RE: Submission to OBJECT AGAINST the redevelopment of the Convention centre, Exhibition and Entertainment precinct.

APPLICATION No. SSD 5752

SUBMISSION FOR APPLICATION No. SSD5752

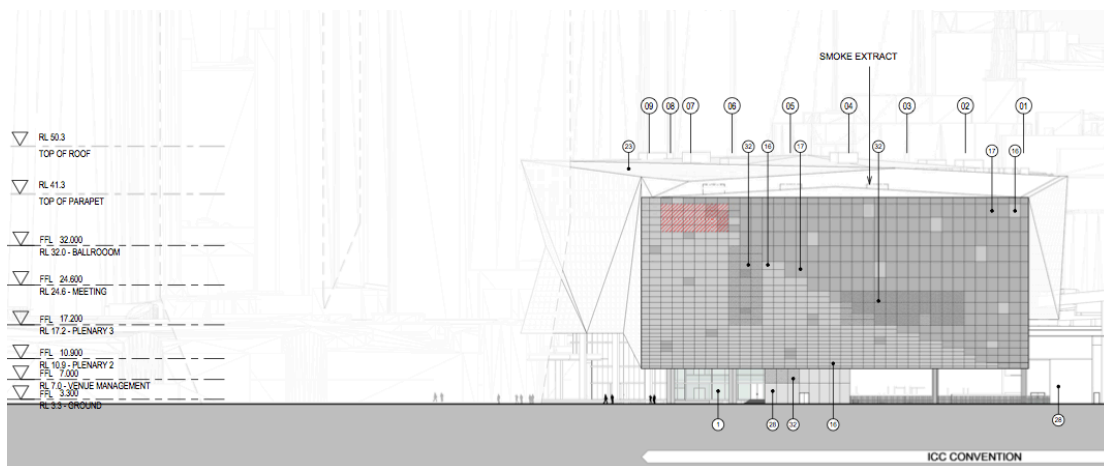
We firstly object to the height of the proposed new ICC convention centre which is nearly to the top of the Goldsbrough's current height.

In the DA plans the proposed height is RL 50.3 which will block the entire view to Darling Harbour and the city from the Goldsbrough's eastern facing apartments. There is supposed to be a concept of view sharing in the city but in this case the whole of the eastern view of the Goldsbrough will be blocked out by the new ICC convention centre.

In place of the current city skyline and Darling Harbour view there will be a flat blank metallic wall in its place, which is the rear of the proposed ICC convention building. The front of the ICC building looks to be nicely designed with glass and is broken up in angles, but the Goldsbrough will be facing an ugly flat back wall made of aluminum and mainly Grey.

Please see the diagram of the back of the ICC convention centre below , which will be approximately the same height as the Goldsbrough.

This is the walkway being removed

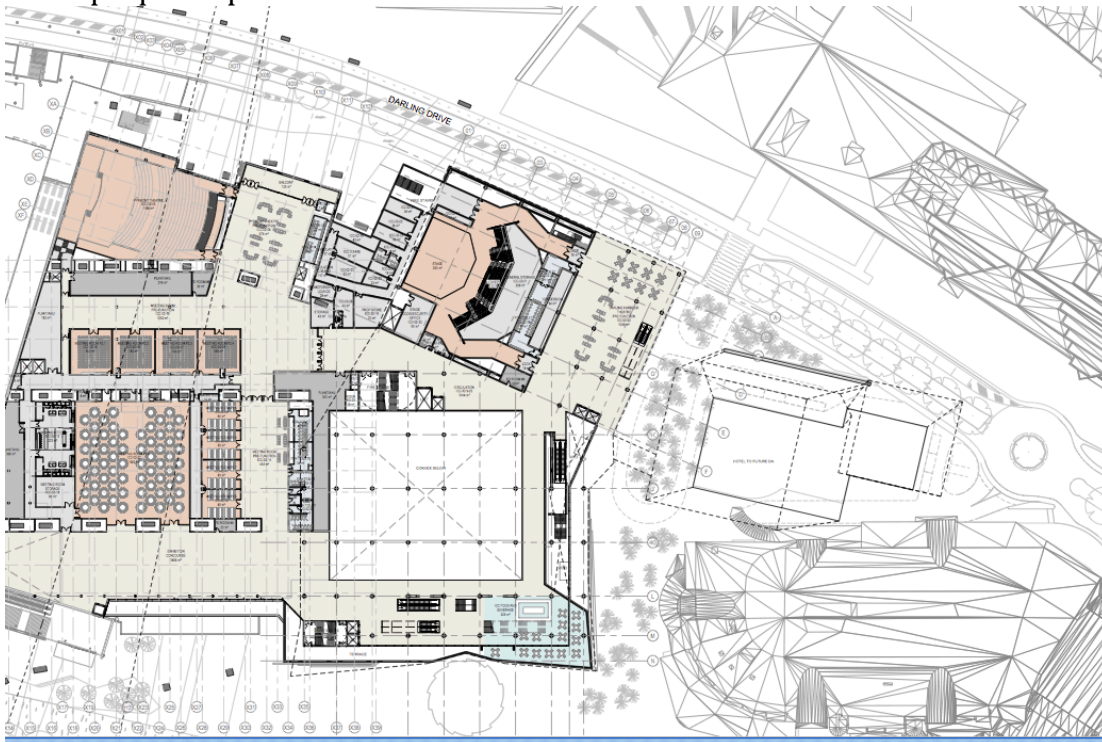
The proposed changes at Darling Harbour seem to take away an extremely important thoroughfare for the residents and guests of the Goldsbrough. From the plans it looks like the current overhead pedestrian walkway next to the Convention monorail station is being removed. Currently it is the easiest and safest walkway to enter the Darling Harbour precinct from the Western side.

From the Architectural drawings below it shows how the current walkway is removed in the proposed plan

**Proposed
June 21 Winter
9:00am**

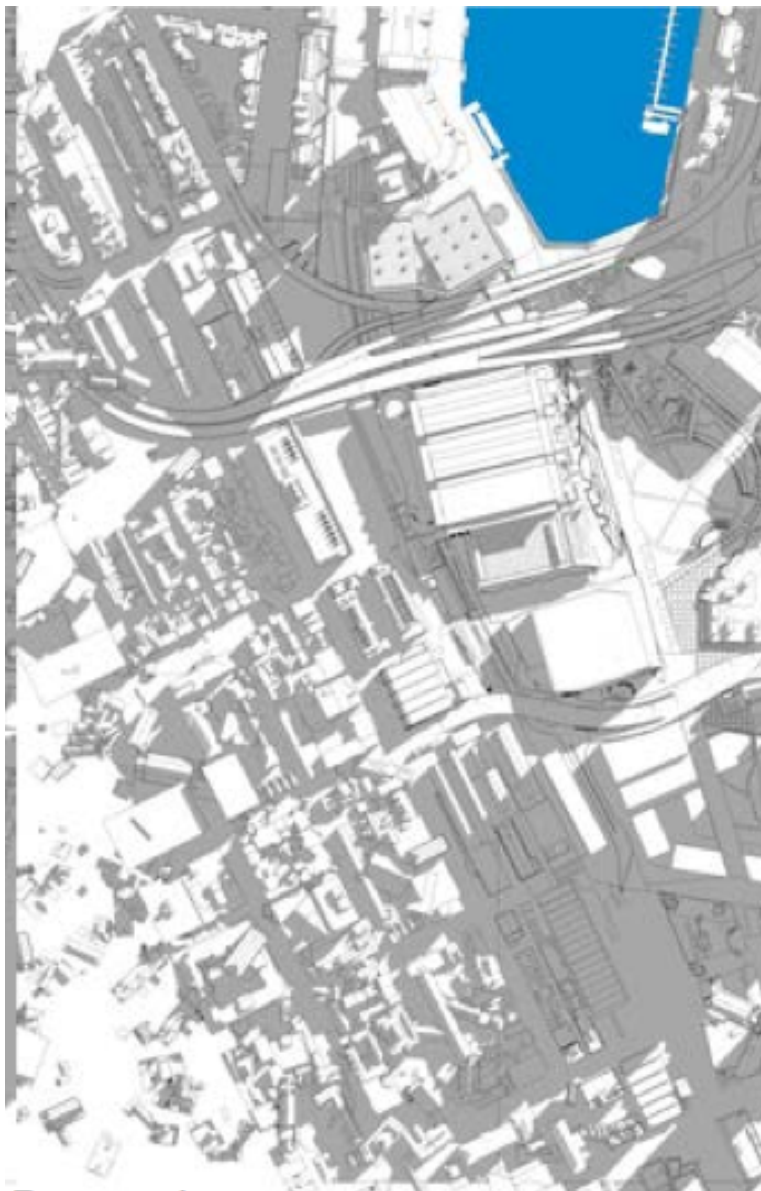
The ICC shadow diagrams show that there will be significant overshadowing of the Goldsbrough from the new ICC and towers, taking away morning sunlight in the all important winter mornings. This will result in increased heating costs for the apartments as well as the loss of valuable morning winter sunlight.

From the Shadow analysis diagrams in the DA it shows a significant loss of sunlight on Pymont St in front of the building and the Eastern face of the Goldsbrough in winter. This is in direct contradiction on trying to make Sydney's buildings more environmentally friendly.

See Shadow diagram below from DA submission.

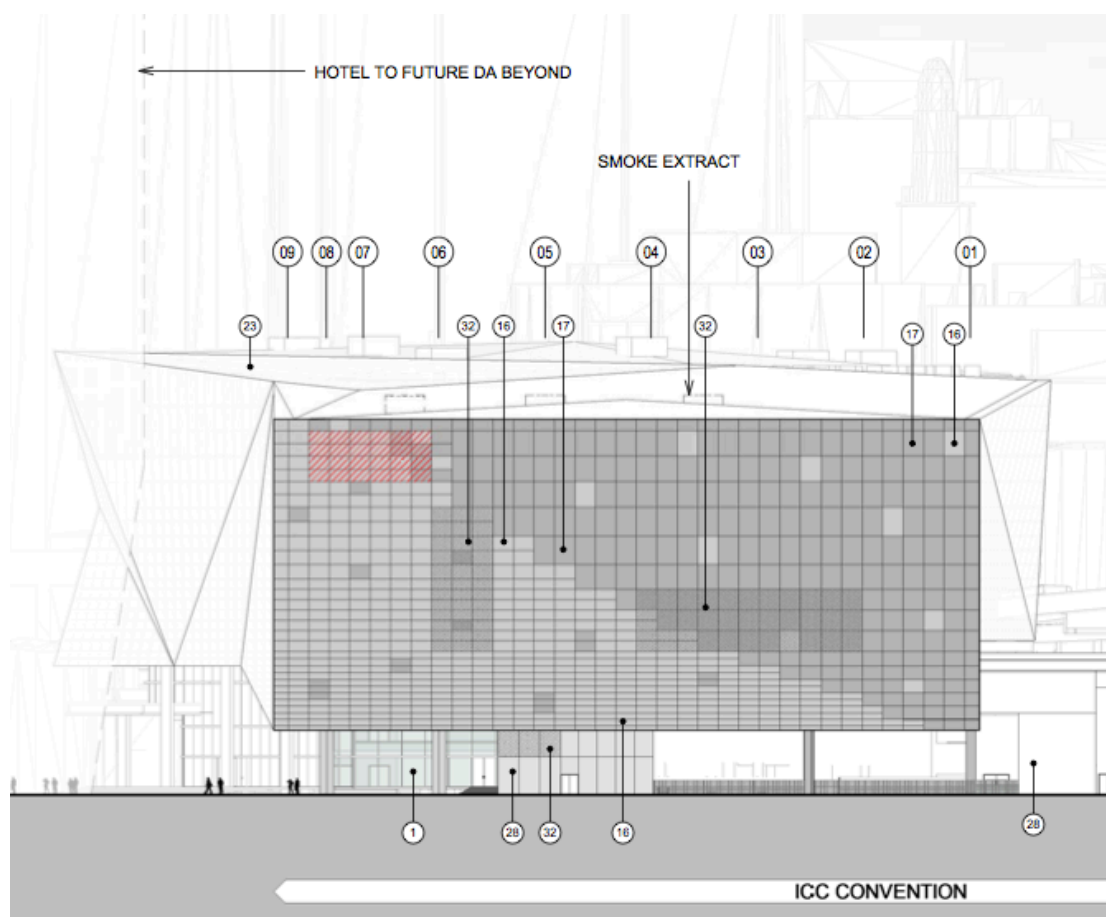
In the DA plans it shows that this will be a mainly Grey metal panel wall which will just look like a Grey metal barricade from the Goldsbrough. All the architecturally appealing glass frontage is kept for the Eastern (Darling Harbour facing) face of the building. All the publicity shots show the view of the East face yet all the Goldsbrough will see is the ugly utilitarian Western face.

If the view from the Goldsbrough is to be dominated by the ICC then at least some regard should be paid to the fact and the Western face of the ICC modified to be more aesthetically appealing. The western face could be architecturally articulated and made of materials that don't look like a metal barricade.

See Diagram below for view of the Western face of the ICC facing the Goldsbrough. Note the scale of this wall in relation to the people in the picture.
